Comments on Rancho Canada Village Specific Plan DEIR

Carmel Valley Association, Comments on RCV DEIR, March 1, 2008, page 10

Carmel Valley Association comments:
"Recirculated Draft EIR" Rancho Canada Village Project
August 31, 2016
Page 25 of 50

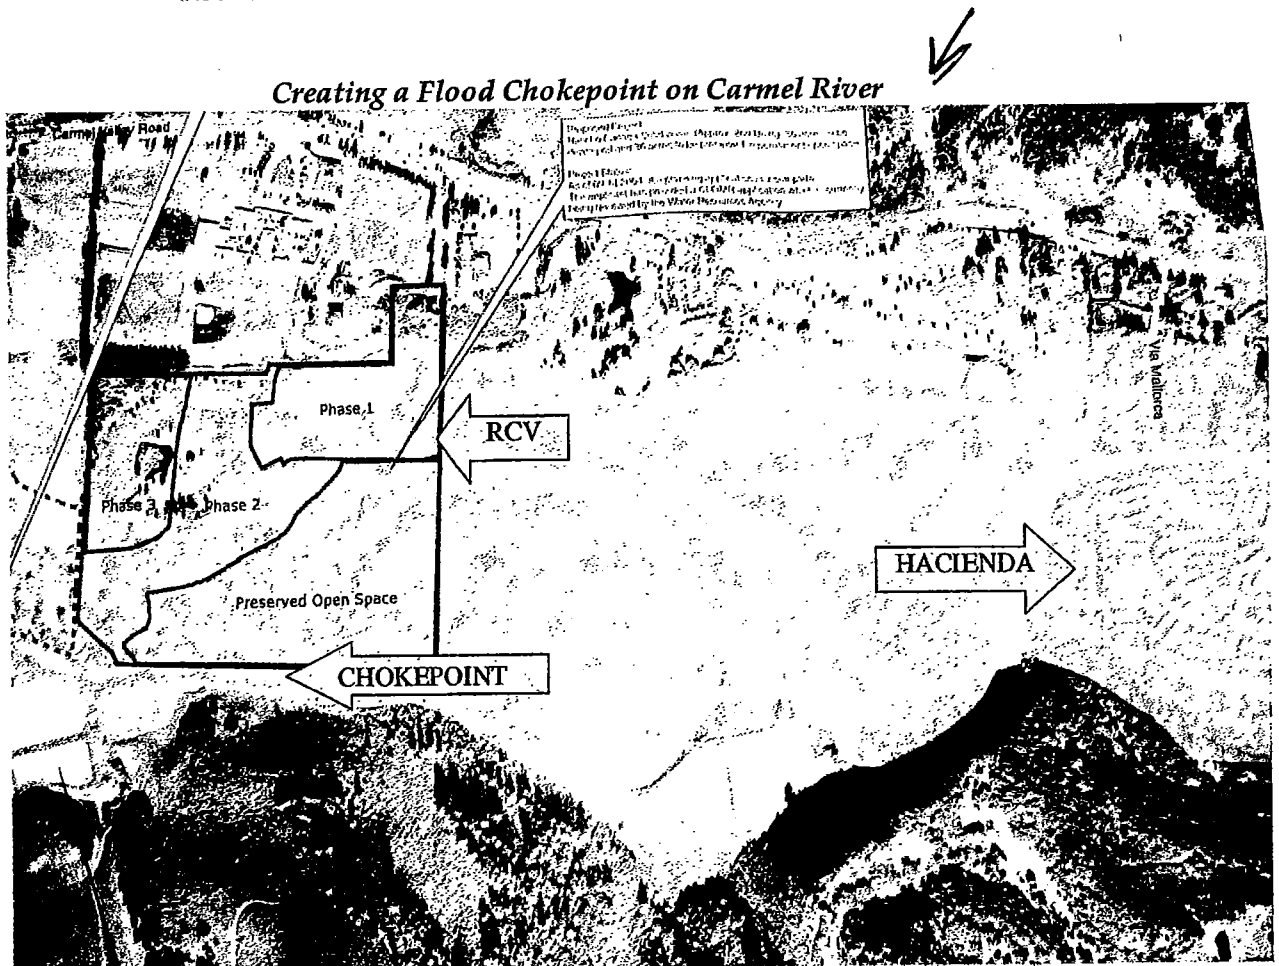
The DEIR significantly fails to address major flooding problems associated with the project, both in terms of upstream flooding as a result of the virtual earthen dam that is to be created as part of this project, and as a result of the impact of the newly displaced 100,000-200,000 cubic yards of water in a major flood event. The major fatal hydrology flaw in the DEIR is that it fails to analyze in a serious way - or at all - the potential flood impacts from the project on properties upstream and downstream from RCV.

- The 200,000 cubic yards of total fill are proposed to angle from a north-easterly to a south-westerly direction on the site property, ending at a height of at least 11 feet on the north bank of the Carmel River. Immediately across the river, a mountainous ridgeline ends near the south bank of the Carmel River. In effect, this will create a chokepoint or funnel running roughly north-south across the floodplain of the Carmel River, with only a narrow passage where the river normally flows. The EIR should thoroughly investigate and discuss the impacts of floodwaters.

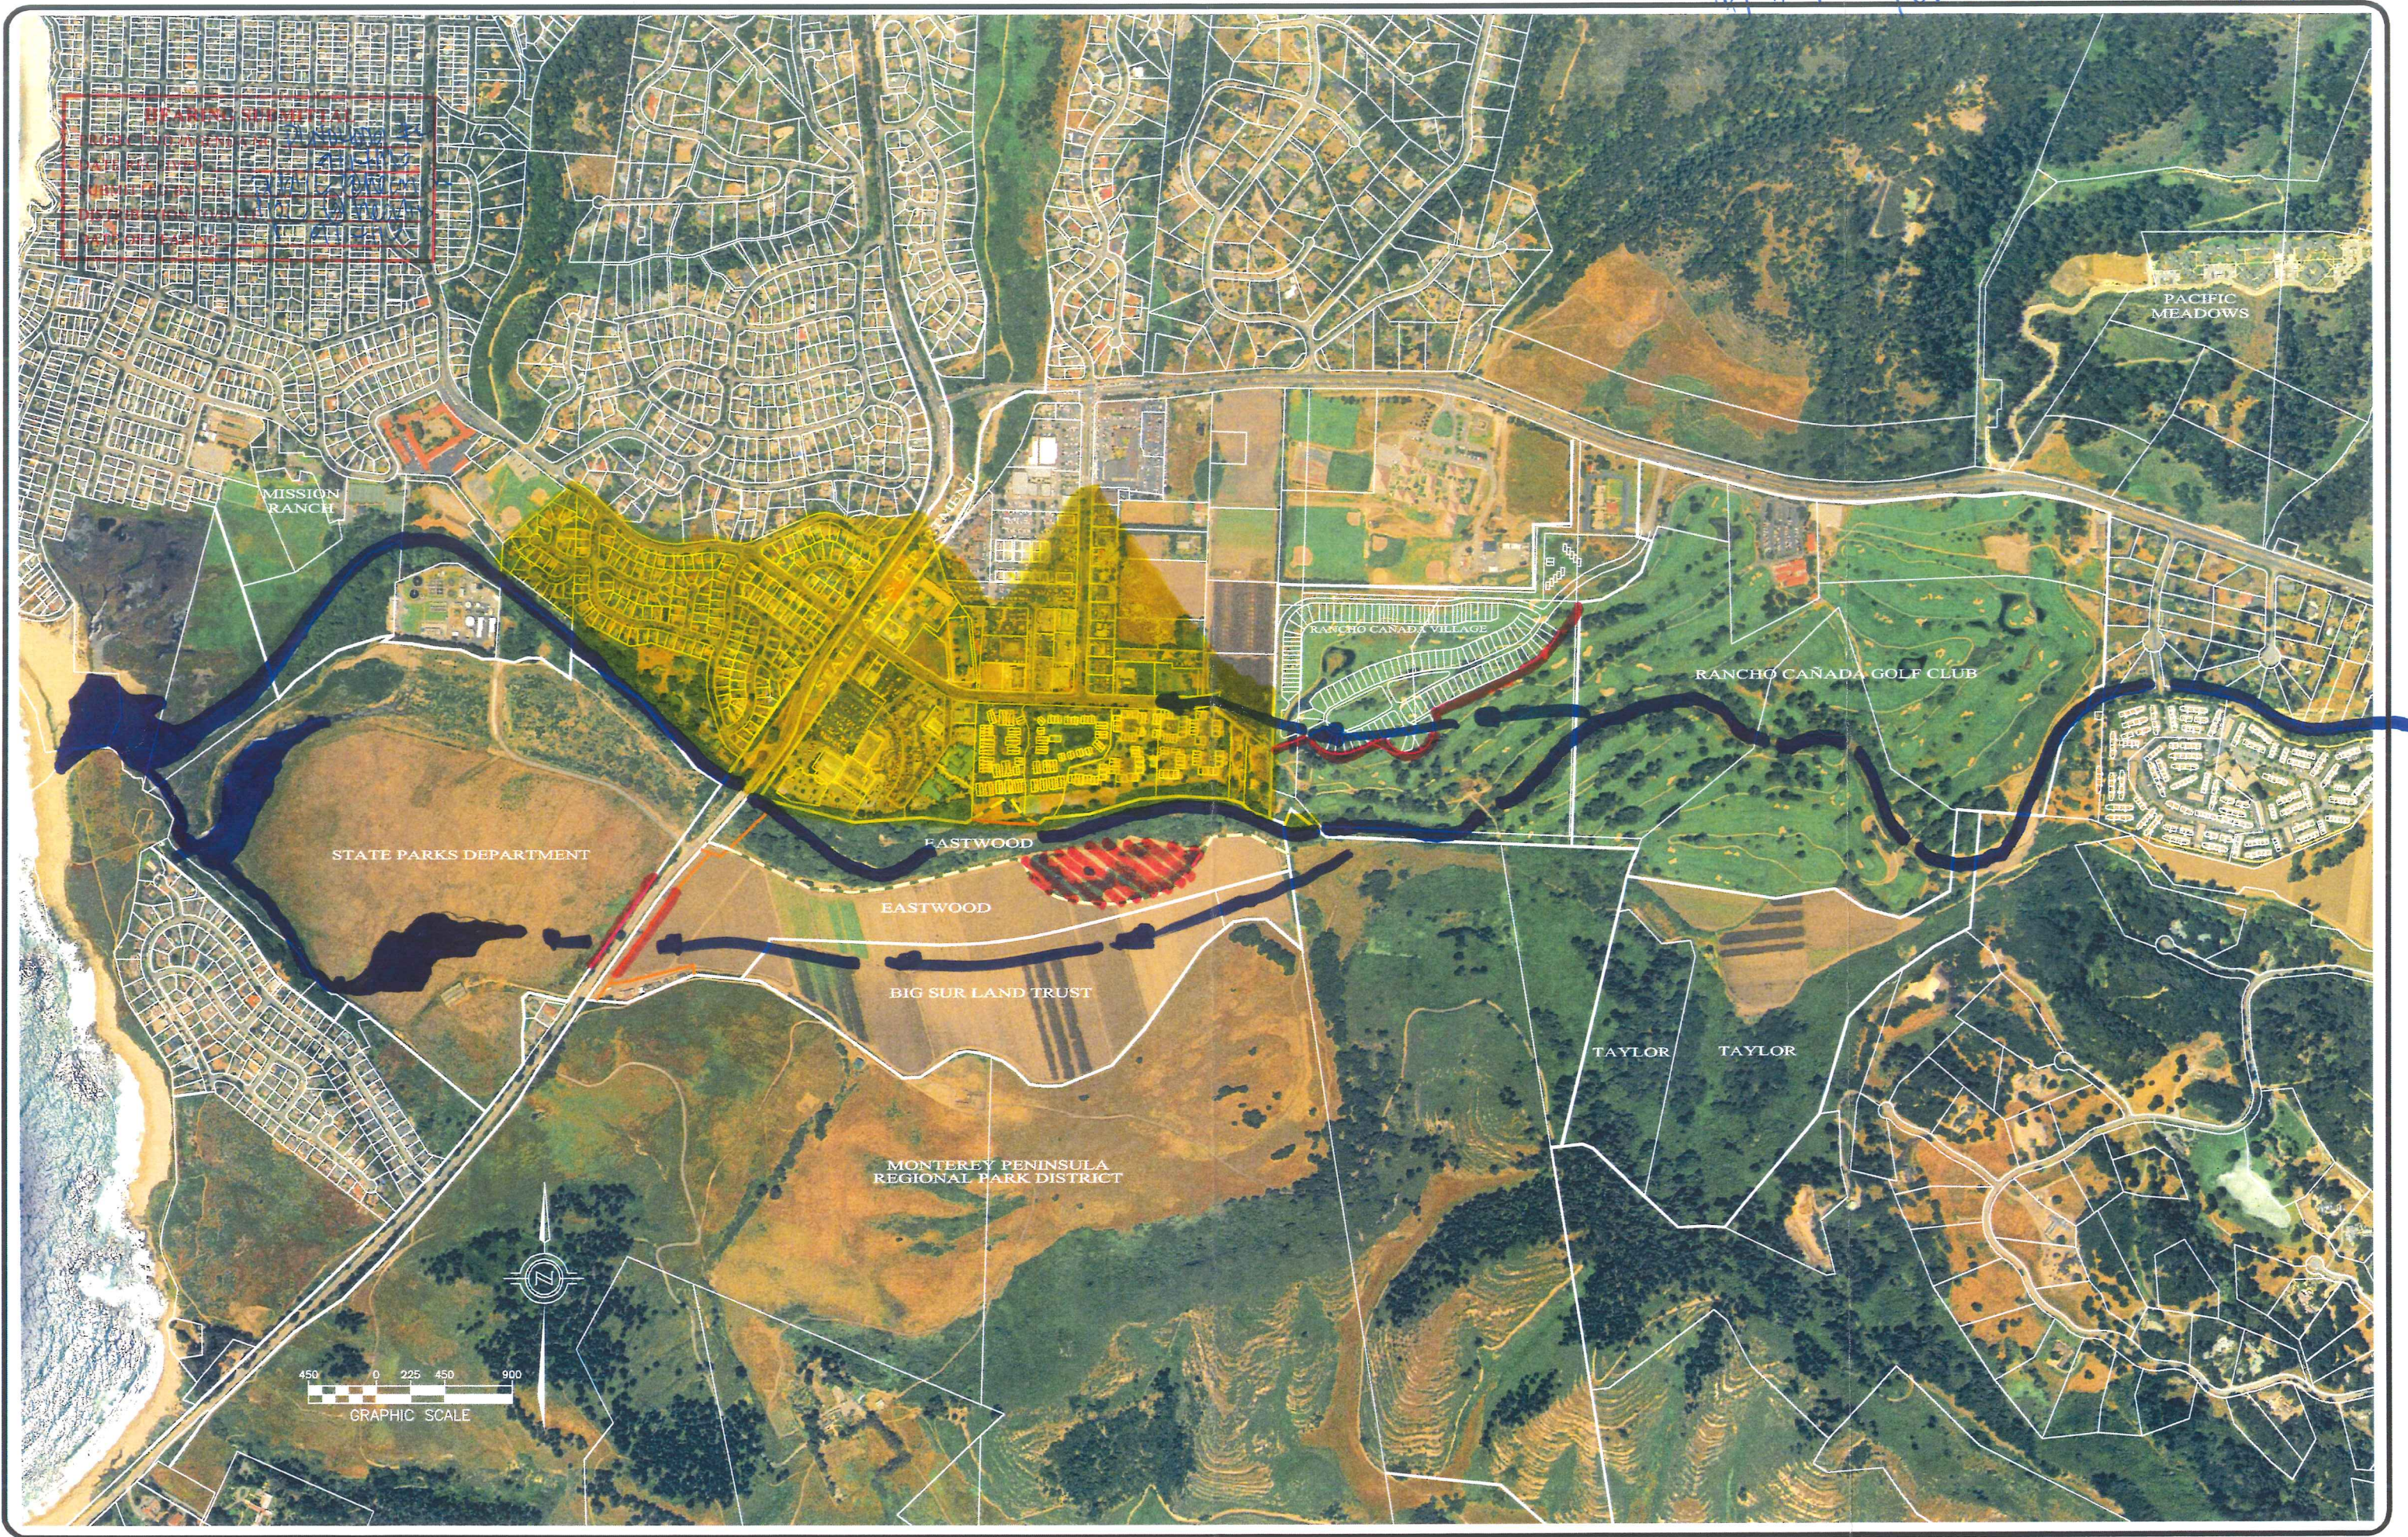
- The so-called “blister” lies downstream on this proposed narrowing of the river, so its removal will have little or no impact on floodwaters backing up behind the chokepoint.
- In its responses to questions and comments, has the DEIR modeled the impacts of the chokepoint? Where is the evidence of that model, and has the model been peer reviewed? We had it peer reviewed by a leading national expert on river flooding (attached) and he found significant omissions and errors in the DEIR. If the DEIR has not analyzed the impacts with an accurate and appropriate model, the DEIR information is not reliable.

Figure 1. Plot of 15-minute-interval daily traffic volumes on Highway 1 from Ocean Ave. to Carmel Valley Rd. The highest sequential volumes occur near mid-day. The RDEIR incorrectly assumed that peak periods are 7-9 am and 4-6 PM, those periods shown as dotted red lines.

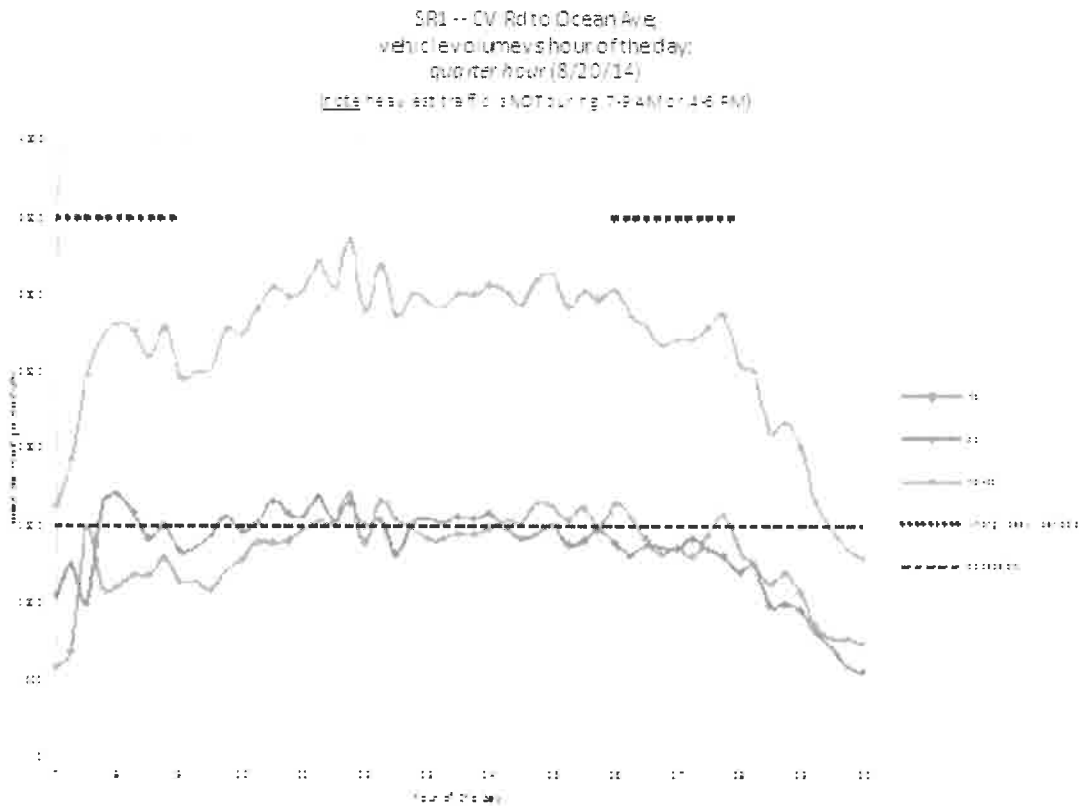
which taints the entire traffic impact analysis, underestimates impacts, and renders useless results. (See Figure 1 and its caption. The graph is provided by CVA, based on the RDEIR data on pdf p. 886.) This is one example among many of the RDEIR's improper and inadequate methodology.

The RDEIR analysis assumed that periods of peak traffic were between 7 and 9 AM and between 4 and 6 PM (see RDEIR p. 3.7-9; also RDEIR Appendix E pp. 1, 3). The assumption is not supported. Total traffic on the Ocean Ave.-to-Carmel Valley Rd. segment of SR1 was not at its peak during those hours. It peaked at 11:45 AM with significantly higher volume (see Figure 1 in this letter) than during the 7-9 AM and 4-6 PM periods. Thus, the RDEIR assumed peak periods that do not comport with actual data reported in the RDEIR traffic study.

Figure 1 in this letter uses the RDEIR’s own data. Figure 1 shows that the traffic quarter-hours of 10:15 am to 4 PM each contain cumulative traffic (NB and SB) higher than or approximately equal to the highest cumulative traffic counts during the RDEIR-claimed “peak hours” of 7-9 am and 4-6 PM.

The differences between actual peak traffic times and assumed peak traffic times, and the consequent differences in traffic volumes that are based on those different times, would significantly and materially change the conclusions of the traffic analysis, both for segments analyses and for intersections analyses. It is impossible to quantify the differences without (1) accurate reporting of the times of actual observation of the traffic and of (2) the observed volumes at those times. The RDEIR peak hour results are based on the incorrectly assumed and vague two- hour peak periods. No evidence was provided to support the assumed peak period choices.

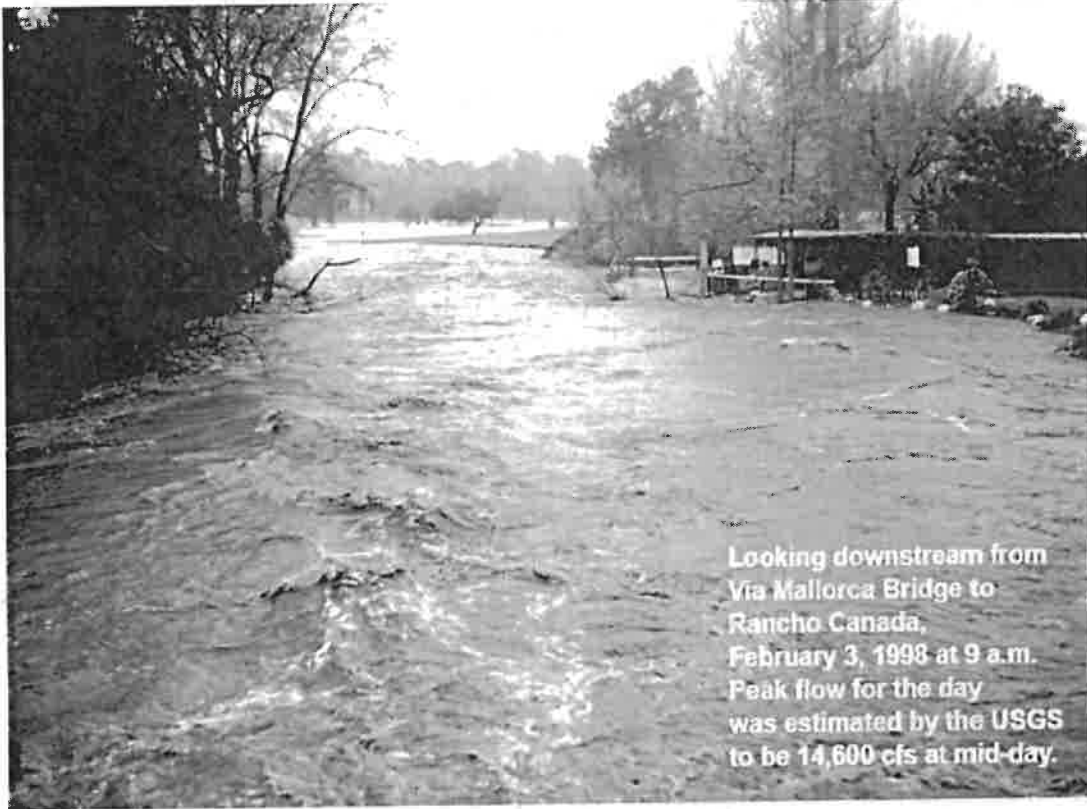
- Why was the model fixed to show the water surface elevation at 33.81 feet? It would have been more appropriate to allow the model to compute its own final elevation, rather than fixing the elevation ahead of time. Please respond in full.

- The model should also consider the high tide elevation that influences the lagoon area. In its analysis, the EIR investigation should include

evaluating and calculating the backwater affects that will cause higher elevations upstream.
